# HARTING Product Change Notification

PCN/ InduCom/14/11/ABCD

Title: **Inducom Hood size 1 (9pol) Top entry and accessories**  
New generation

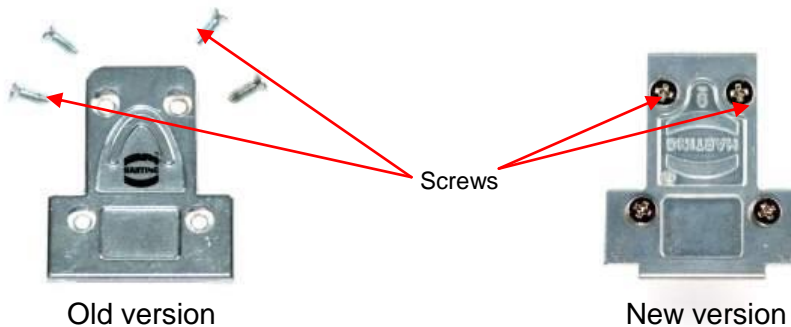
- External and internal dimension are identical

Note : the new version do not have the noses in the connector edge area
